General Bid Bulletin No. 8
16 June 2021

**THE MALOLOS-CLARK RAILWAY PROJECT AND THE NORTH-SOUTH RAILWAY
PROJECT SOUTH LINE COMMUTER PACKAGE CP NS-01: PROCUREMENT OF
ELECTRICAL AND MECHANICAL SYSTEMS AND TRACK WORKS (IFB No: 21-040-3)**

This General Bid Bulletin is issued to amend/clarify certain provisions in the Bidding Documents for the above-mentioned Project. Please refer to the attached Annexes of this General Bid Bulletin for details:

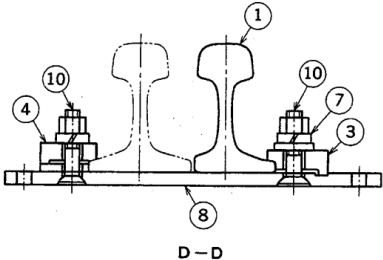
18	Volume II, Section VI ©, ERT-23, 1.12.7,	<p>What is the maximum thermal stress for CWR to considered? From Bidder experience, it is 785 kN. Please confirm.</p>		<p>The Bidder's understanding is correct. Maximum thermal stress is 785kN.</p>
19	Volume II, Section VI ©, ERT-32, 1.14.1, 4) The coefficient of elasticity shall be 25-30MN/m.	<p>These two clauses contradict each other. Bidder understands the coefficient of elasticity to be used as 25-30 MN/m.</p>		<p>The 25-30MN/m is the bottom elasticity of the material at the sleeper rail location. While the 250-300MN/m is the side elasticity of the material.</p>

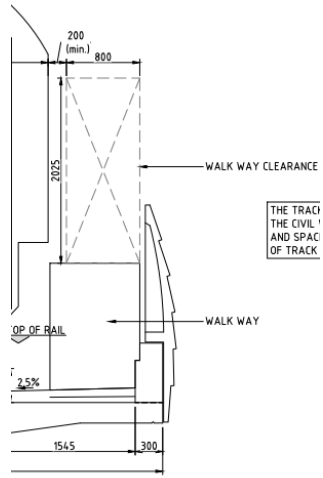
22	Volume II, Section VI, ERT-49, 1.23 14), a) The walkway frame and base plate to support the deck for walk surface shall be made of hot dipped galvanized steel according to ASTM A123/A123M and/or ASTM A153/A153M or an equivalent	Material for walk way along the track: base plates and handrails are hot dip galvanized steel. Bidder understands that deck for walk surface can be hot dip galvanized steel grating or concrete slab or FRP. Please confirm.		The Bidder's understanding is correct. However, any proposed material and coating shall meet the design life criteria.

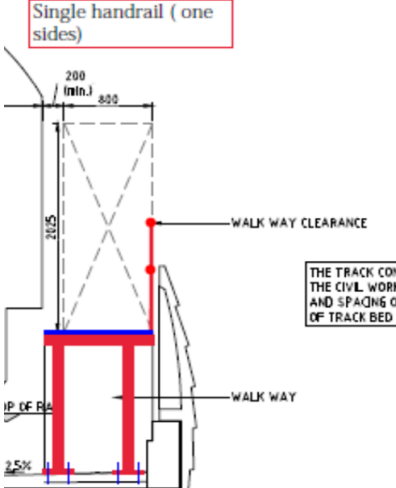
Item No.	Volume Section No. Page No. Clause No. / Title Reference Text	Clarification Request	Proposed Revised Text (if any)	Response
23	Part 2, Vol. 3, Section VI, d), Pdf 66/321, MCRP-DWG.GEN-TK-0215 (REV.03),	<p>According to Cl 1.17.1 14) and 1.17.2 5), Turnouts shall be based on JIS however the given drawing for depot and Mainline is not align with JIS. In JIS, there are no any rail pads beneath the rail and pads beneath the tie plate (Elastic pad or Intermediate Pad underneath the rail) are being used. Therefore, Bidder would like to clarify configuration/drawings shall be according to JIS. (JIS E1301, 1303, 1304, 1305, 1306 and 1307) without rail pads.</p> <p>In addition, synthetic material will behave as an elastic material, thus no any additional elastic material beneath the rail is required.</p> <p>For reference JIS E1307</p> 		The drawing in MCRP-DWG-GEN-TK-0215 is for reference only. For JIS 60 Turnouts, The Turnout fastening assembly should comply with JIS standard.
